Southern Nuclear Operating Company  
Vogtle Electric Generating Plant Units 3 and 4  
Request for License Amendment:  
Structural Design of Auxiliary Building Floors (LAR-16-009)

- Enclosures:
- 1) Vogtle Electric Generating Plant (VEGP) Units 3 and 4 – Request for License Amendment Regarding Structural Design of Auxiliary Building Floors (LAR-16-009)
  - 2) Vogtle Electric Generating Plant (VEGP) Units 3 and 4 – Proposed Changes to Licensing Basis Documents (LAR-16-009)

**Request for License Amendment Regarding**  
**Structural Design of Auxiliary Building Floors**  
**(LAR-16-009)**

DESIGN SUMMARY OF FLOOR AT ELEVATION 135'-3"  
 AREA ~~4-2~~ (MAIN CONTROL ROOM CEILING)

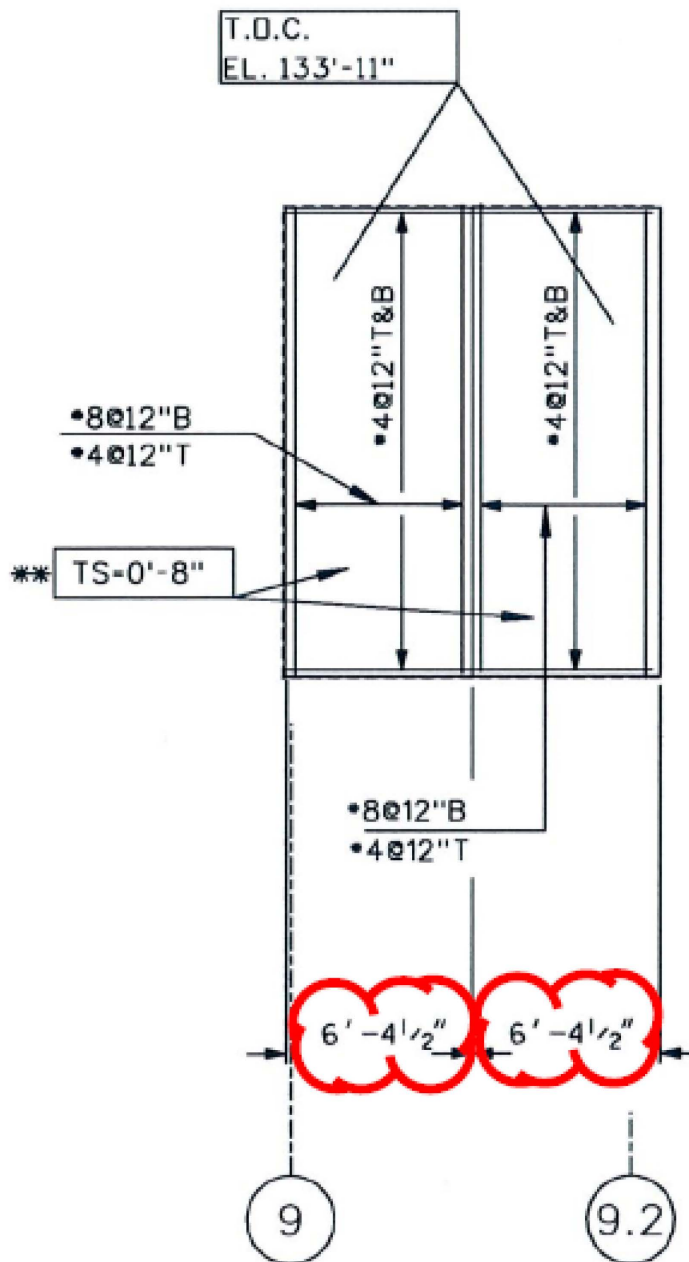
Change the values in UFSAR Table 3H.5-13 to reflect the revised design. Reformat and revise the information in the table to present the information in a more understandable manner. The reinforcement included to resist negative bending provided by the design is added to the table to provide additional information about the floor design instead of information about bending moment. Add a statement that excludes reinforcement and studs in the area of penetrations, openings, or other obstructions. The information on calculated required shear stud spacing is removed from the table because the design spacing satisfies AISC N690 requirements and is more limiting than the calculated spacing. Change the designation of the area in the table title. Change the reference to the table number in UFSAR Subsection 3H.5.4 from "3.H.5-13" to "3H.5-13."

- H. Change to UFSAR Table 3H.5-13 (Change Activity 7)
  - 1. Revise the table title to change the area identified in the title.
  - 2. Reformat the table and add text to improve comprehension.

- 3. Define construction loads.
  - 4. Revise the calculational results for maximum bending moment and maximum shear force and round values to two significant digits.

- 5. Define tension steel.
  - 6. Add an exception for reinforcement near penetrations and other interferences.
  - 7. Revise to add values to the table for the reinforcement to resist negative bending.

- 8. Add an exception for shear studs near penetrations and other interferences.
  - 9. Add a clarification that the design shear strength is not reduced for in-plane axial forces.

- 10. Remove from the table the information on shear stud calculated required spacing.
- I. Change to UFSAR Figure 3H.5-8 (Change Activity 9):
  - 1. In the view labeled Floor EL. 133'-11" (Precast Concrete), change the panel width from 5'-11" to 6'-4½".

FLOOR EL. 133'-11"  
(PRECAST CONCRETE)  
NOTES 1, 3, 6, 7, 16, 17

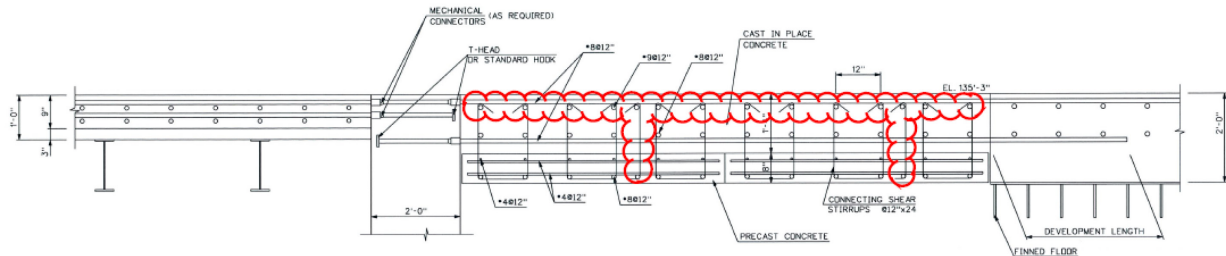
Revise UFSAR Subsection 3H.5.3.1 and UFSAR Figure 3H.5-8 to show the width of the precast panels to be 6'-4½". Revise UFSAR Figure 3H.5-8, Section C, to show three double stirrups and one single stirrup connecting the precast panel and cast-in-place concrete. Revise UFSAR Figure 3H.5-8, Sections C and F, to reorient the hooks on the stirrups to be in the plane of the double stirrup.

**UFSAR Figure 3H.5-8, Auxiliary Building Operations Work Area (Tagging Room) Ceiling –  
Revise the information for Floor EL. 133'-11" (Precast Concrete) as shown below.**

**UFSAR Figure 3H.5-8, Auxiliary Building Operations Work Area (Tagging Room) Ceiling –  
 Revise the information for Section C (Looking West) as shown below.**

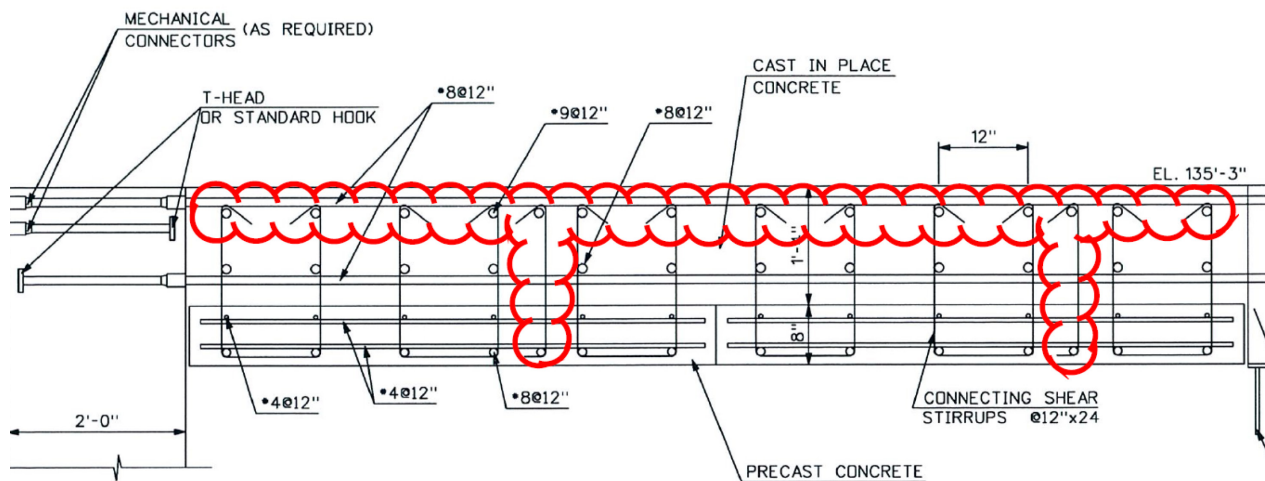
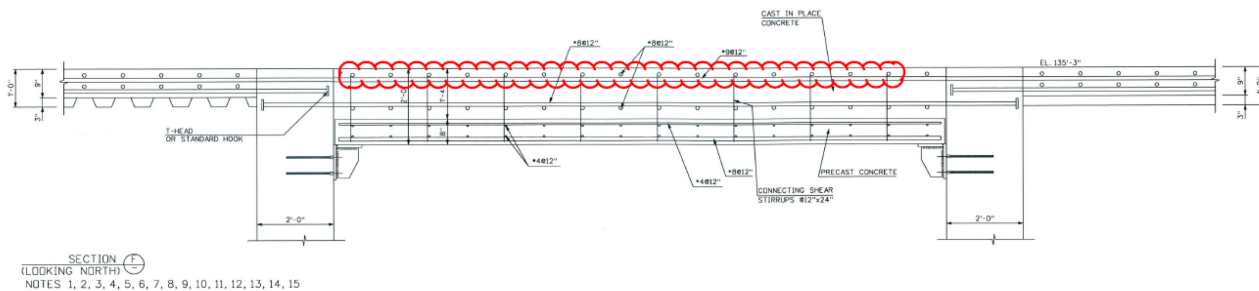
- 2. In Section C, add a row of single stirrups to each of the two precast panels.
  - 3. In Section C and F, reorient the hooks on the stirrups to be in the plane of the double stirrup.

**UFSAR Figure 3H.5-9 (Sheet 1 of 3), Auxiliary Building Finned Floor – Revise the information as shown below.**

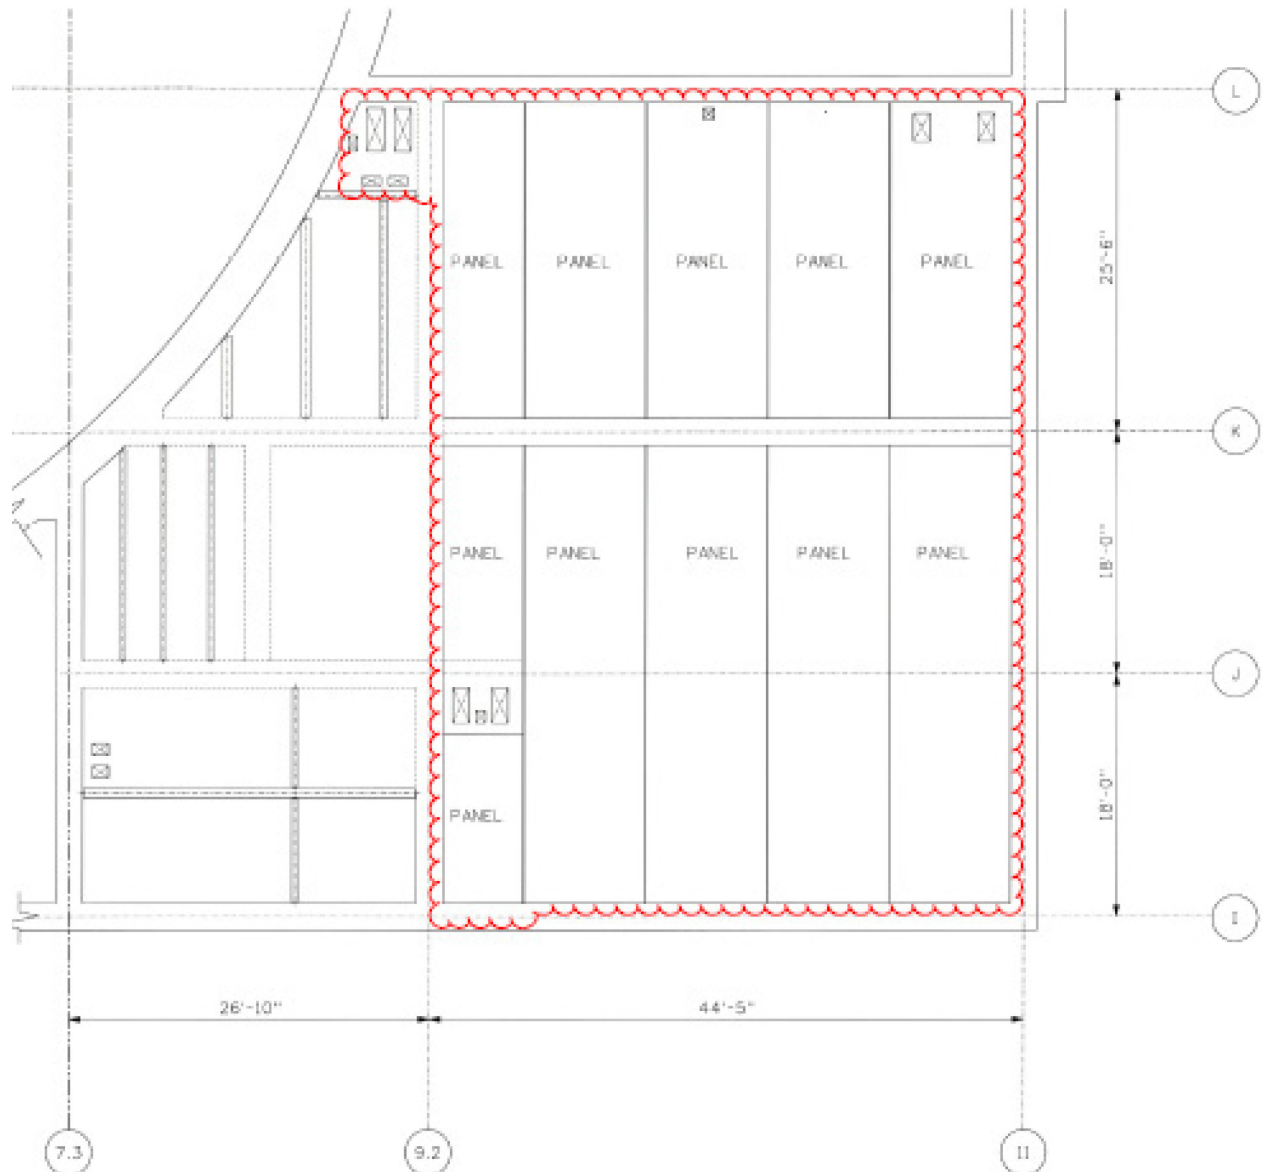
UFSAR Figure 3H.5-9, Sheet 1, shows four finned floor steel plates (panels) between column lines 9.2 and 11 from column lines I to L. It is proposed that the number of plates between column lines 9.2 and 11 be increased to facilitate fabrication and construction.

Openings for HVAC ducts in the ceiling of the main control room are shown in the finned floor critical section UFSAR Figure 3H.5-9, Sheet 1. A proposed change relocates these openings on the figure because of rerouting of the HVAC ducts. The openings are moved out of the floor above the main control room to the floor above another room within the control room envelope. In addition, openings shown on the left side of the figure adjacent to column line 9.2 are reconfigured because of final design changes in routing.

- J. Change to UFSAR Figure 3H.5-9, Sheet 1 (Change Activities 1, 3, and 4):
  - 1. Revise the figure to show five finned floor steel plates between column lines 9.2 and 11 from column lines I to L.

- 2. Revise the figure to move the rectangular openings for HVAC ducts from along column line 11 near column lines I and J to along column line L near column line 11.

3. Add notes to the figure to provide the following information:
  - a. State that the section shown is a specific location and other locations will have variations in design details.

- b. State that the number of steel panels in the floor varies.
- K. Revise UFSAR Figure 3H.5-9, Sheet 2, as follows: (Change Activities 1, 2, 5, and 8):

1. DETAIL SHOWN IS SPECIFIC TO THE REINFORCED CONCRETE FLOOR AT EL. 135'-3" (MAIN CONTROL ROOM CEILING). REFER TO SUBSECTION 3H.5.4 AND OTHER NOTES FOR ADDITIONAL INFORMATION ABOUT DESIGN DETAILS FOR OTHER FLOOR SECTIONS AND FOR CONNECTIONS TO WALLS OTHER THAN THE WALL ALONG COLUMN LINE 11.
2. THE NUMBER OF STEEL PANELS USED TO CONSTRUCT THE FLOOR IS DETERMINED BY THE SIZE OF THE ROOM AND FABRICATOR CAPABILITIES.

**UFSAR Figure 3H.5-9 (Sheet 2 of 3), Auxiliary Building Finned Floor – Revise the information to add the Notes shown below.**

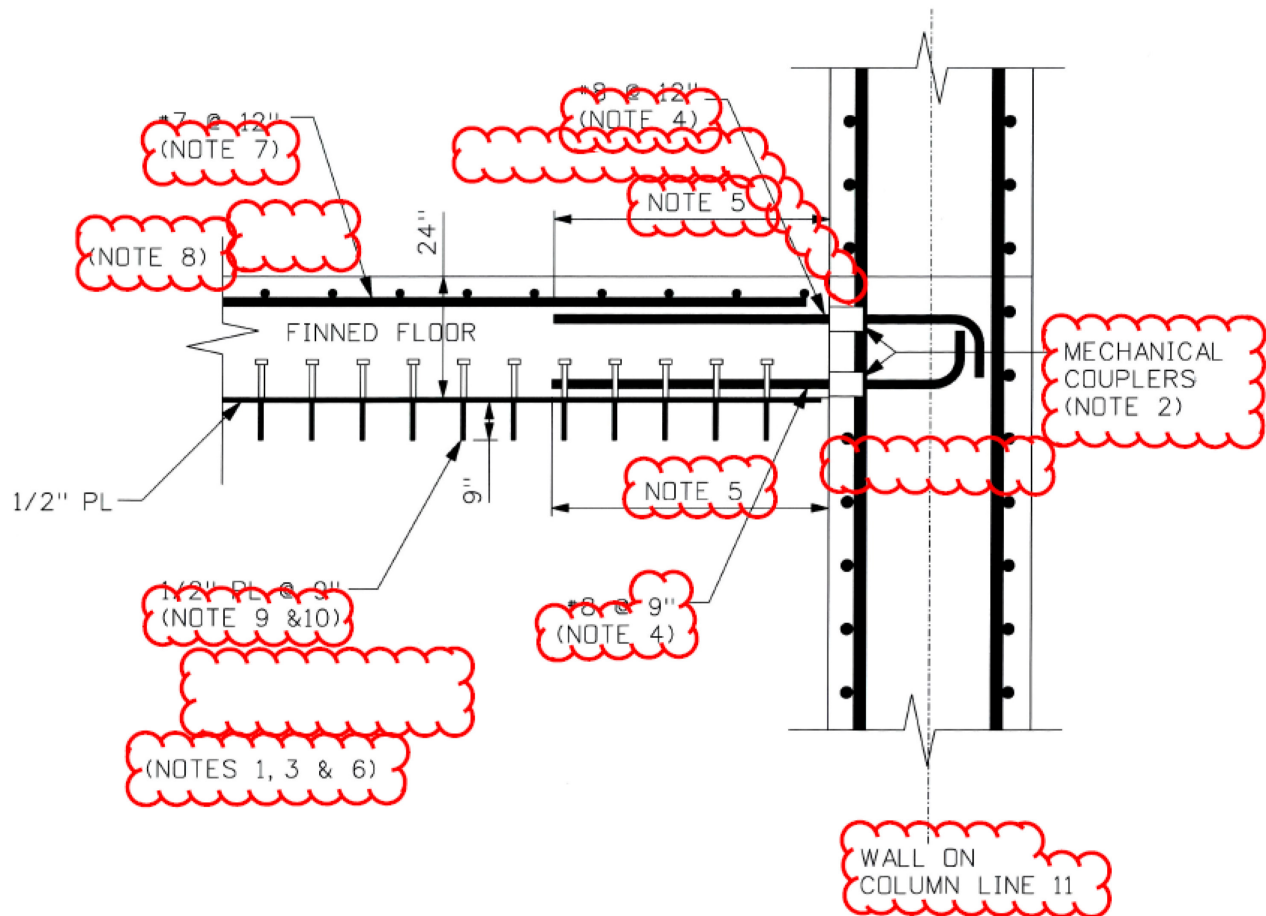
Proposed design changes are identified to the detail reinforcement design of the finned floor to wall connection represented in UFSAR Figure 3H.5-9, Sheet 2. The figure shows a floor to wall connection including reinforcement dowels connected to the wall and studs attached to the steel plate on the bottom of the floor. The figure identifies a length for the dowel for the critical section. The dowel length used for the critical section is not used at all locations. UFSAR Figure 3H.5-9 includes detail fabrication design and construction sequence information that is not needed or appropriate in licensing basis figures. The figure also includes incidental location information that is unnecessary or confusing and should be removed or corrected.

On UFSAR Figure 3H.5-9, Sheet 2, remove the length dimension from the reinforcement bar dowel. This activity does not change the design basis or design methodology for the connection between the floor and wall. The connection design was approved as part of the AP1000 design as represented in UFSAR Figure 3H.5-9, Sheet 2. However, the details of the design methodology and design basis of the connection are not specified or discussed in the UFSAR. These details are added as notes on the figure addressing splice length criteria and stud sizing and spacing, and a supplemental evaluation was conducted to document the basis for the connection design and methodology. The supplemental evaluation demonstrates in detail that the force transfer in the connection design satisfies the ACI 349 and AISC N690 code requirements and appropriately transfers the loads through the connection. Therefore, the supplemental evaluation demonstrates the applicability of the ACI 349 and AISC N690 code requirements. Revise the spacing of the lower dowels to optimize construction.

Remove the designation of the construction joint shown between the floor and wall and the gap between the steel plate and the wall because these elements may vary based on fabrication considerations and construction sequence. The North – South designator is removed as it is not needed. The designation of Wall 11 is changed to “WALL ON COLUMN LINE 11” instead of using the drafting convention currently shown because the current designation may be confusing. The change of detail reinforcement design and labeling of the figure does not change the compliance of the finned floors design with codes and standards, including ACI 349 and AISC N690 requirements.

1. Revise spacing of the bottom reinforcement bar dowel to @9"
  2. Remove reference to construction joint
  3. Remove designation of 135'-3" elevation; replace with Note 8

4. Remove size of dowel length; replace with Note 5
  5. Remove information on gap between steel plate and wall
  6. Replace the term "Mechanical Splices" with "Mechanical Couplers"

7. Remove North – South designator
  8. Revise wall designation to say "WALL ON COLUMN LINE 11"
  9. Add notes to the figure to provide the following information:

- c. Identify the requirements for development of headed reinforcement.
    - d. Identify the code requirements for reinforcement size and spacing and provide the range of reinforcement size and spacing.

1. DETAIL SHOWN IS SPECIFIC TO THE REINFORCED CONCRETE FLOOR AT EL 135'-3" (MAIN CONTROL ROOM CEILING). REFER TO SUBSECTION 3H.5.4 AND OTHER NOTES FOR ADDITIONAL INFORMATION ABOUT DESIGN DETAILS FOR OTHER FLOOR SECTIONS AND FOR CONNECTIONS TO WALLS OTHER THAN THE WALL ALONG COLUMN LINE 11.

8. THE ELEVATION OF THE TOP OF CONCRETE IS BASED ON LOCATION AND DESIGN REQUIREMENTS FOR THE FLOORS.
9. THE DESIGN OF THE FINS VARIES AT LOCATIONS NEAR OPENINGS, PENETRATIONS, AND OTHER OBSTRUCTIONS AND DUE TO ATTACHMENTS TO THE FINS AND FLOOR PLATES.

10. THE CENTER LINE LOCATION OF THE SHEAR STUDS MAY VARY FROM THAT OF THE FINS.

**UFSAR Figure 3H.5-9 (Sheet 3 of 3), Auxiliary Building Finned Floor – Revise the information to add Notes as shown below.**

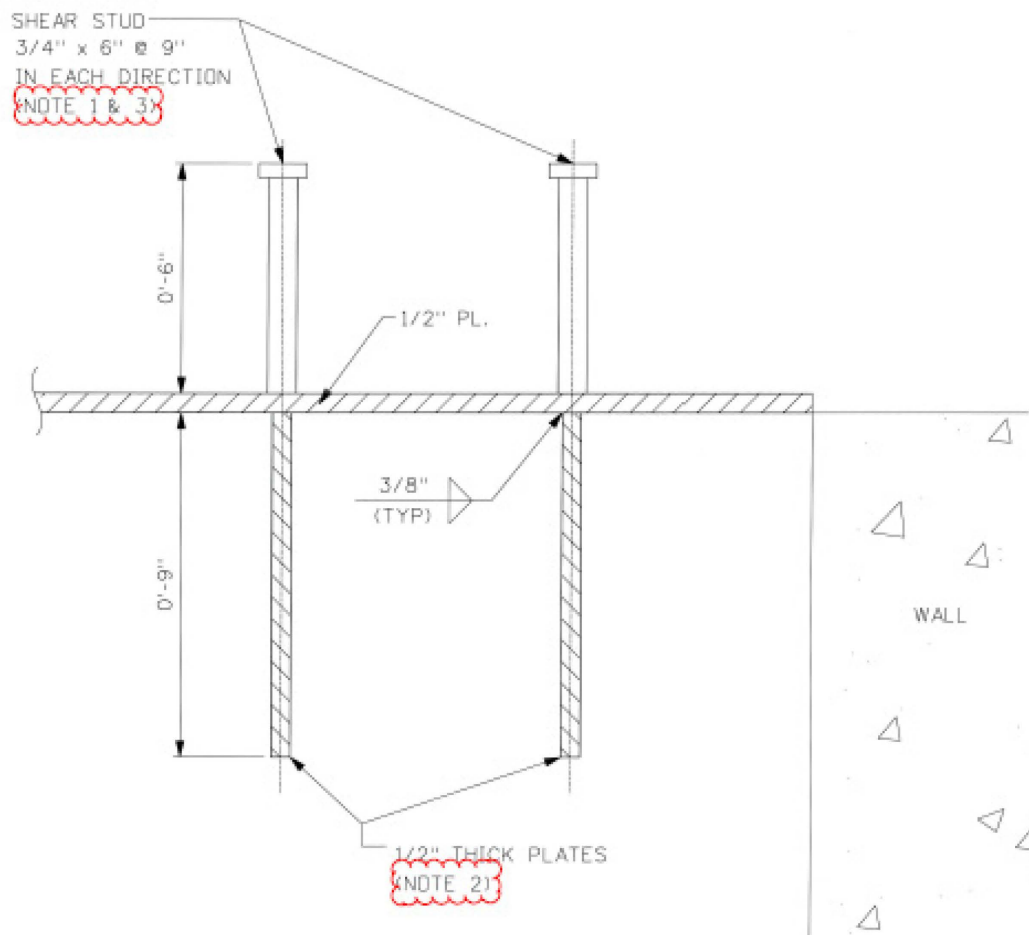
- L. Revise UFSAR Figure 3H.5-9, Sheet 3, as follows: (Change Activity 1):
  1. Add notes to the figure to provide the following information:
    - a. State that the shear stud design shown is for locations away obstructions.
